HAM/WAR US 22  
16.04/0.00 PED  
HAMILTON COUNTY  
WARREN COUNTY

REVIEW COMPLETE

PROJECT DESCRIPTION

RELOCATING EXISTING PED HEADS AND PUSH BUTTONS ONTO PEDESTALS FOR BETTER ACCESSIBILITY, ADDING SIDEWALK AND CURB RAMPS TO MAKE CROSSINGS ADA COMPLIANT. INCLUDES PEDESTALS AND ASSOCIATED CONDUIT, WIRING AND PULLBOXES ALONG US-22 IN HAMILTON AND WARREN COUNTIES

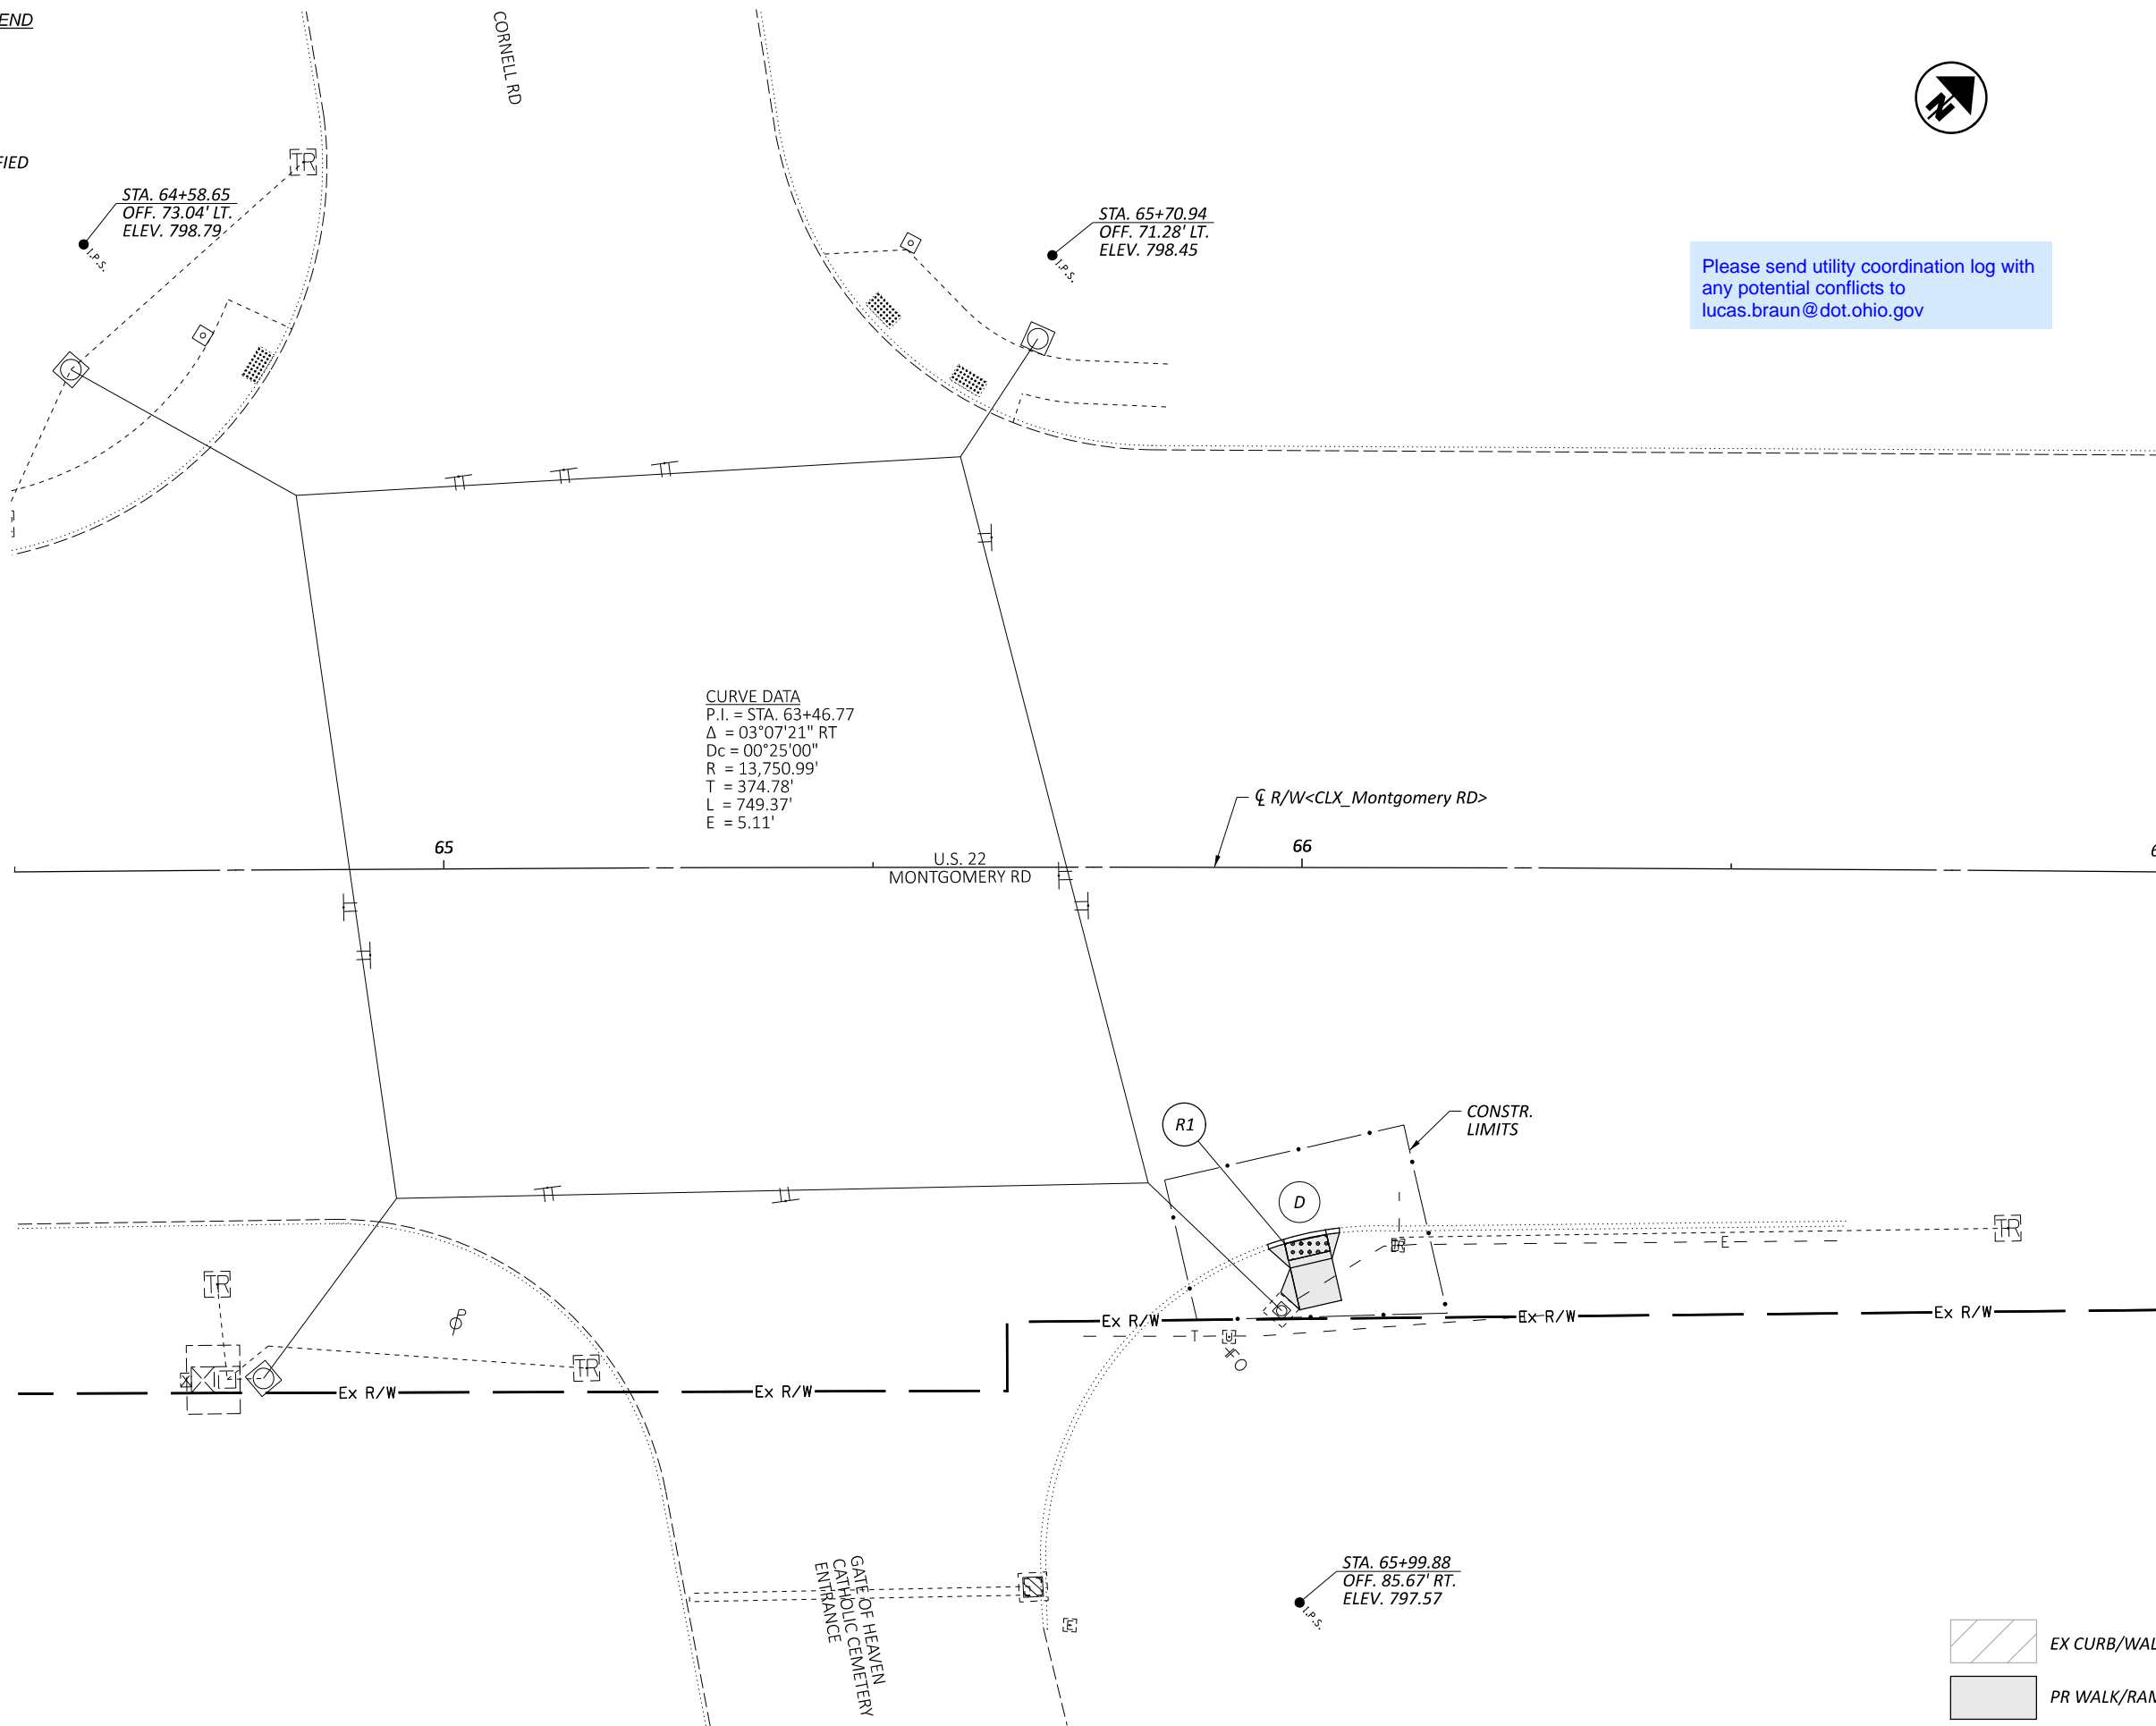
pay item for the pole attachment of the new signs or are these to be field drilled and onto the pole?

The pull boxes to be reused are labeled in the plans. Some locations include the PB at the controller and some do not. Is there a reason for this? I would think the reuse of the controller pull box would be consistent throughout the plans. If there is a reason to not include it with this pay item, it should be stated in the plans.

Review these quantities. The number of plugs should be roughly equal to the number of items relocated off the support, and the number of items reoriented on the same support

**TRAFFIC SIGNAL PLAN  
 US 22 AT CORNELL RD**

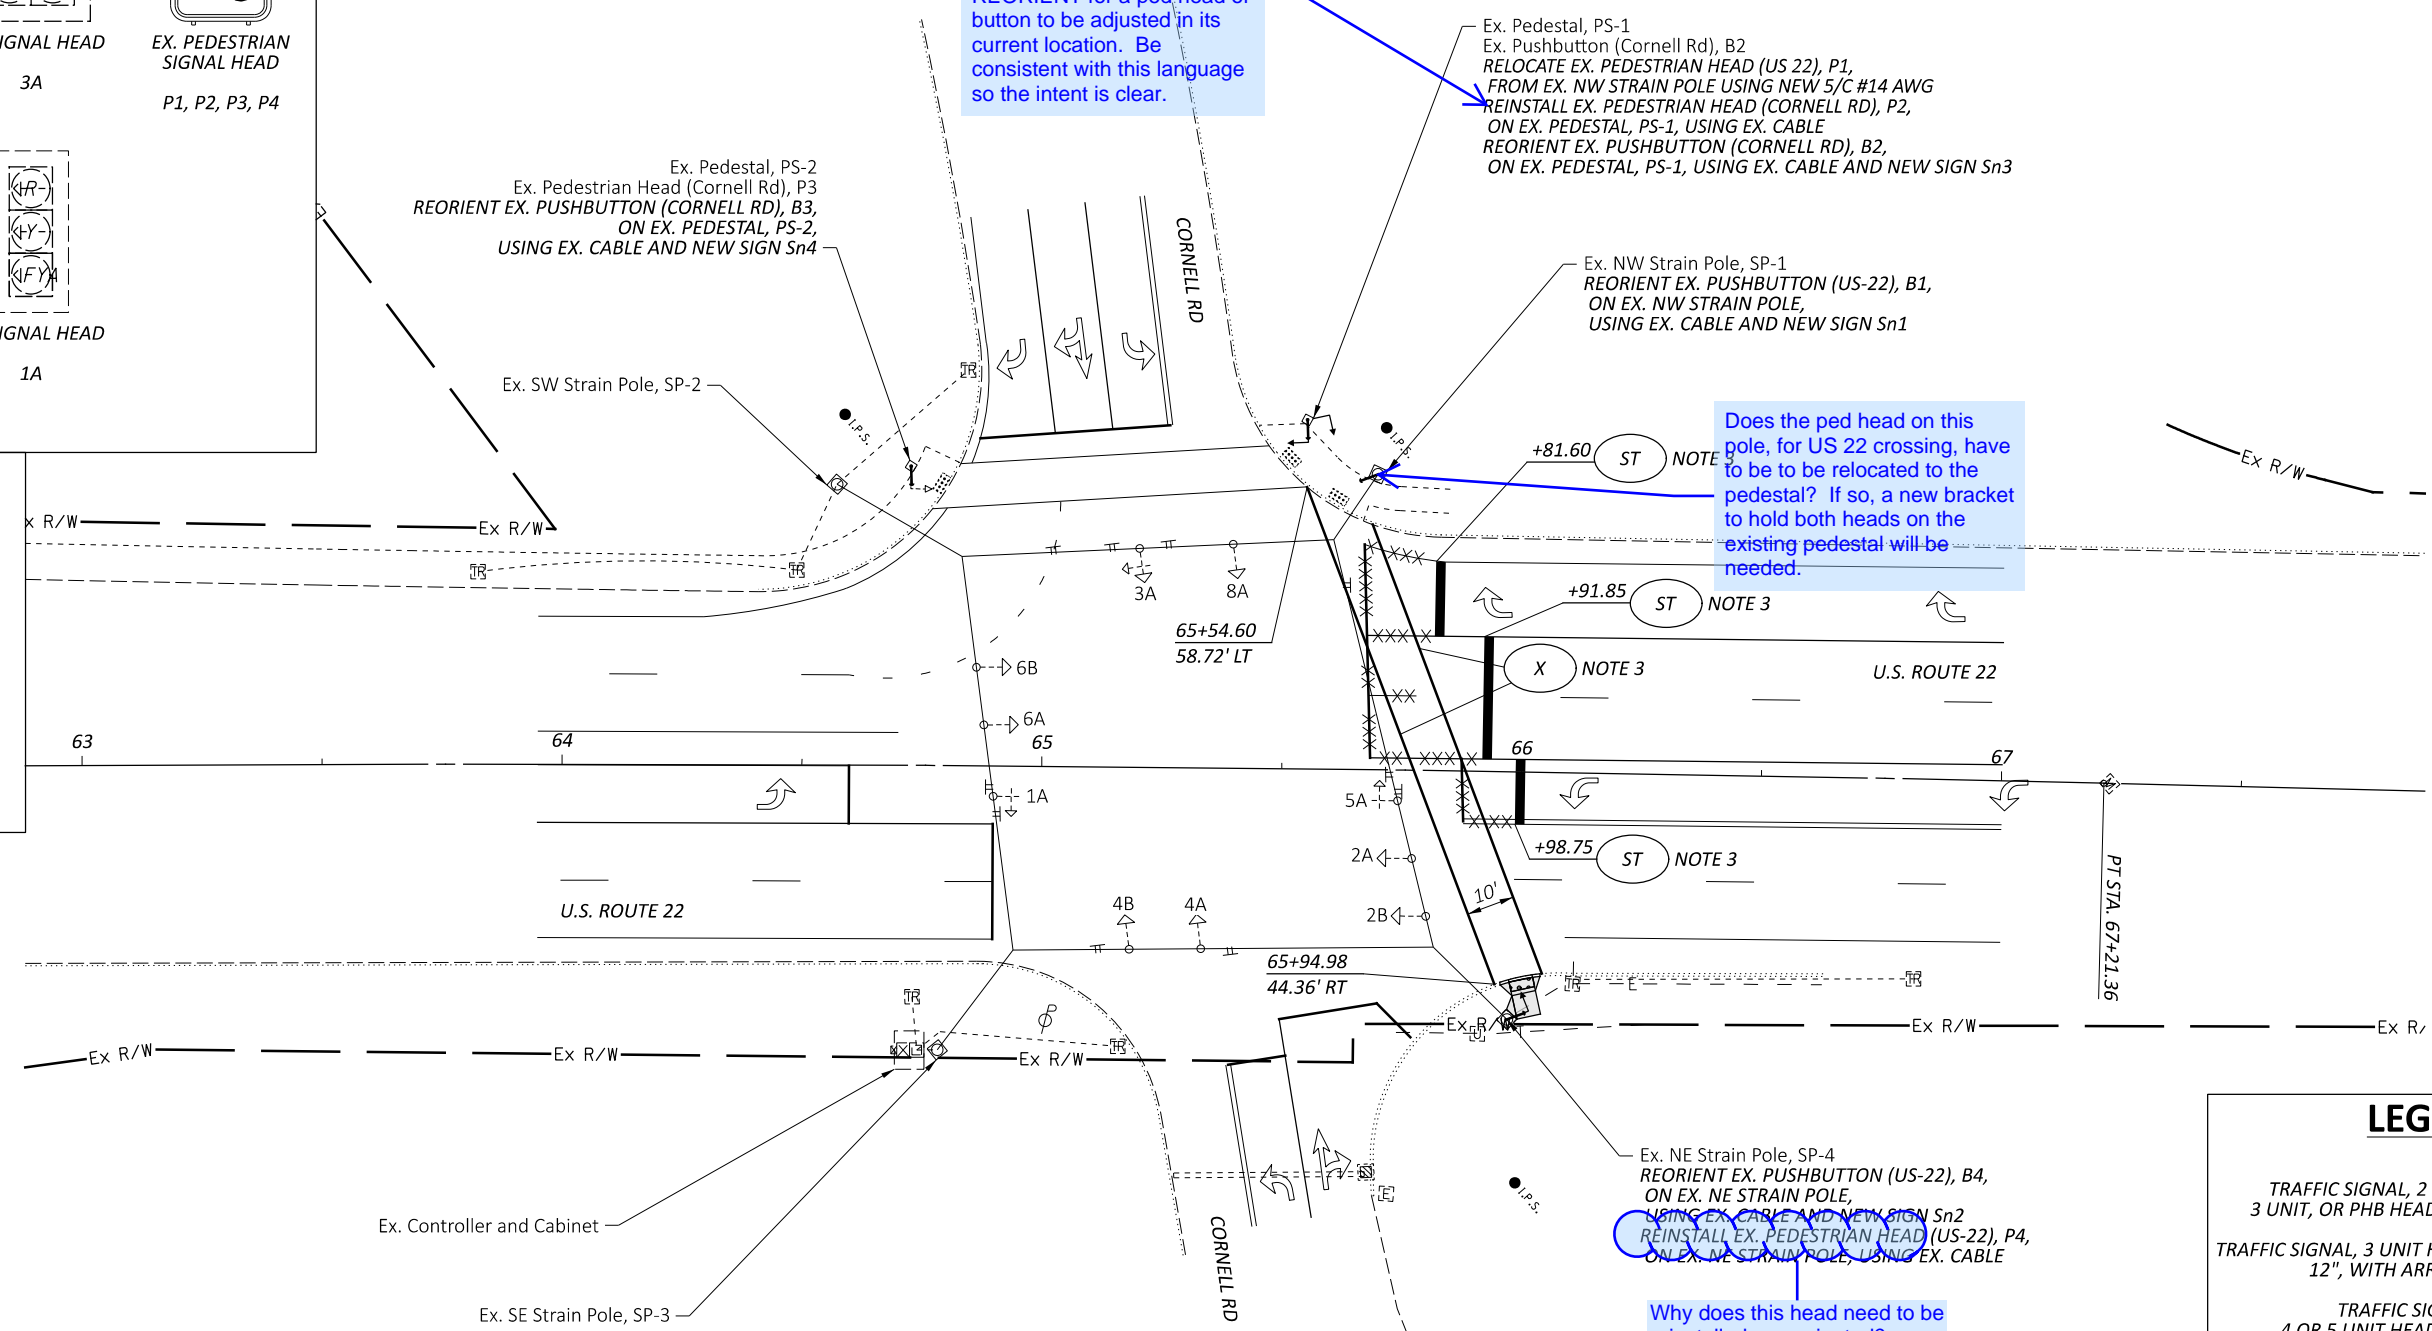
Recommend only using the terms RELOCATE for an ped head or button that is reused elsewhere on the project. Use REORIENT for a ped head or button to be adjusted in its current location. Be consistent with this language so the intent is clear.

Add plan notes to clarify the work and which pay item it is covered with:  
 Reuse of Pedestrian Pushbutton - Consists of relocating an existing pushbutton to the proposed location or reorienting the pushbutton at its existing location to the position noted in the plans.  
 Reuse of Pedestrian Signal Head - Consists of relocating an existing ped head to the proposed location or reorienting the ped head at its existing location to the position noted in the plans.

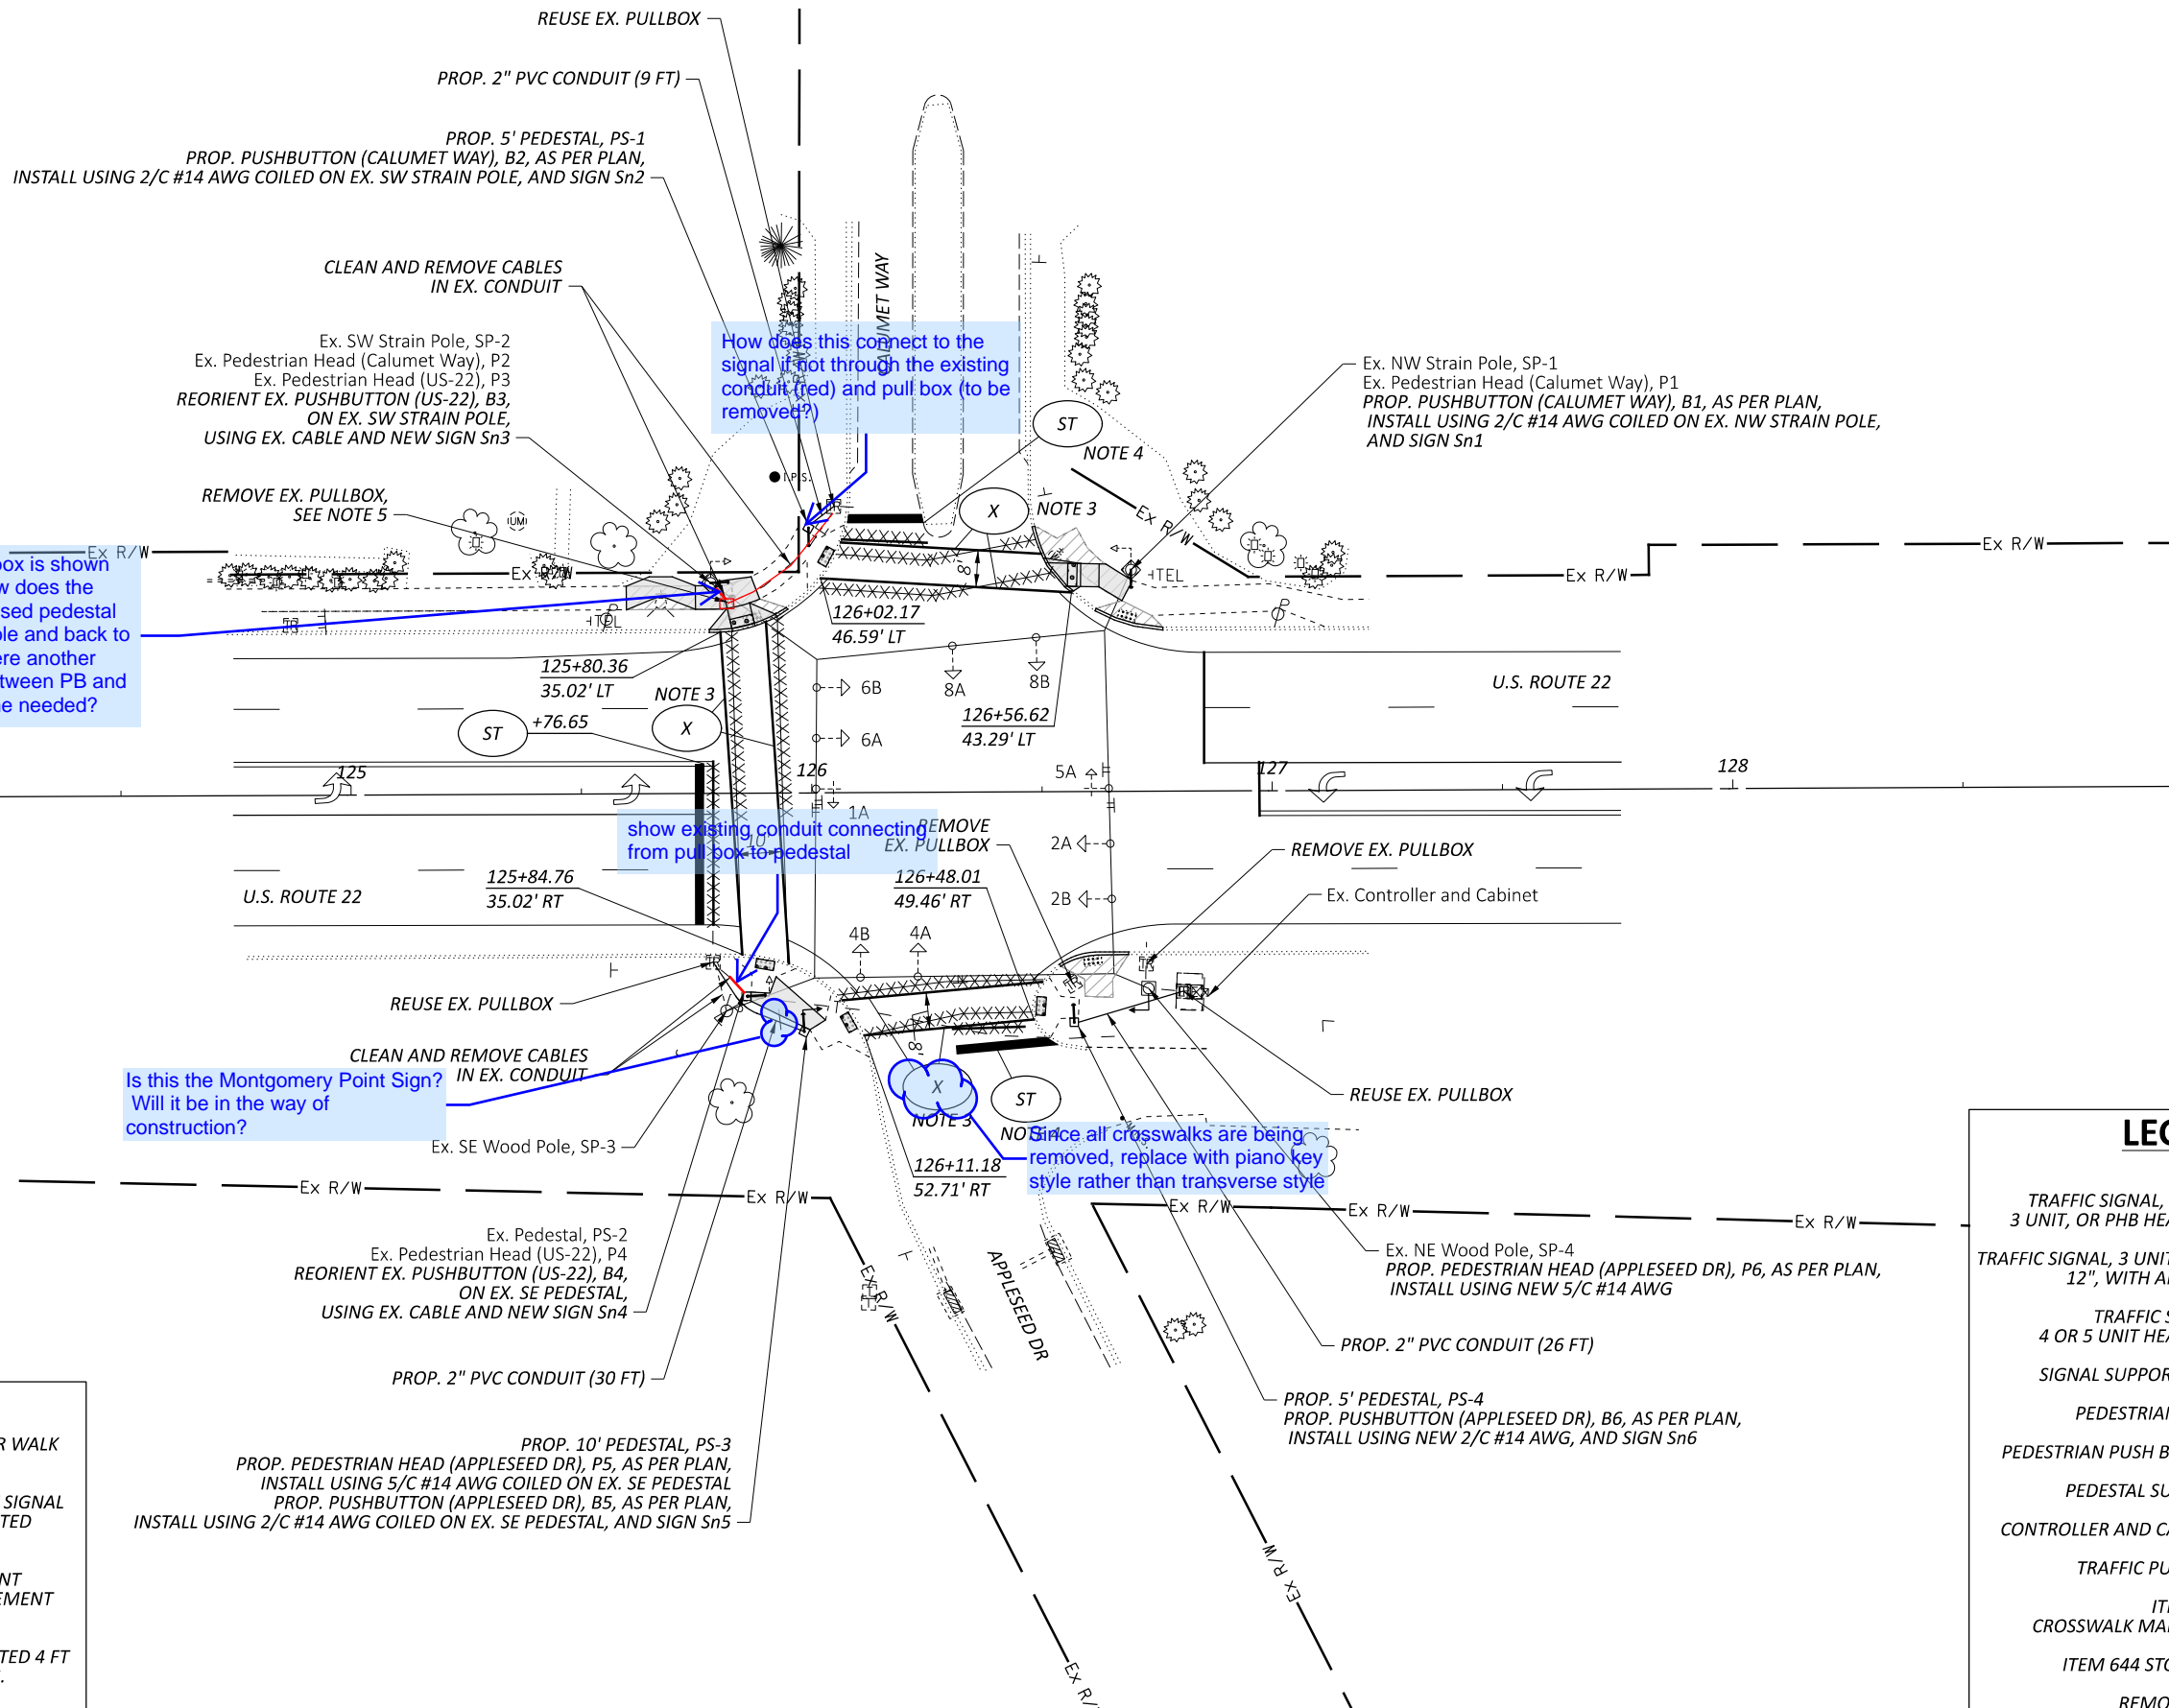
Although this pull box is shown to be removed, how does the conduit from proposed pedestal get to the signal pole and back to the cabinet? Is there another existing conduit between PB and pole or is a new one needed?

Is this the Montgomery Point Sign? Will it be in the way of construction?
